SUNDRY NOTICES AND REPORTS ON WELLS
Do not use this form for proposals to drill or reenter an abandoned well. Use Form 3160-3 (APD) for such proposals.

Epic Energy, LLC, proposes to permanently plug and abandon the Jicarilla Tribal 358 #9 as per the attached procedure:

Re: Permanent Abandonment
Well: Jicarilla Tribal 358 #9

CONDITIONS OF APPROVAL

Proposed P&A

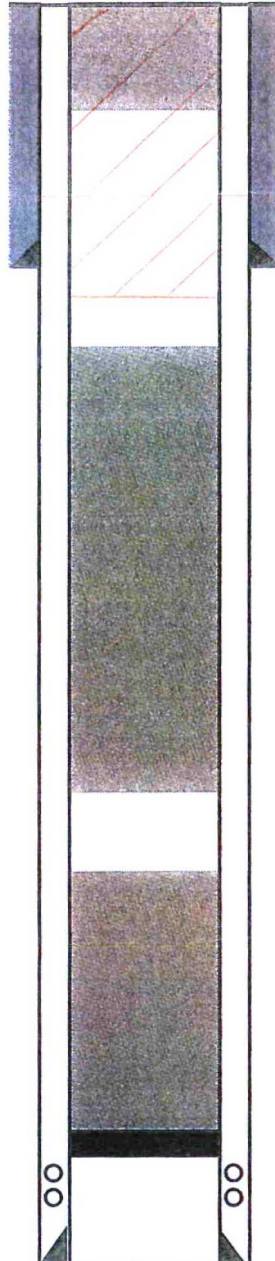
3. Pursuant to the BLM Geologic Report the following changes are to be made (adjust plugs as indicated below):

BLM Tops:
Pictured Cliffs @2650'
Fruitland @2530'
Kirtland @2474'
Ojo Alamo @2310'

I: Spot plug #3 (surface and surface shoe plug) from 255' to surface.

3. Pursuant to the BLM Geologic Report the following changes are to be made (adjust plugs as indicated below):

1. Spot plug #3 (surface and surface shoe plug) from 255' to surface.
2. Spot plug #2 (2524' to 2210')
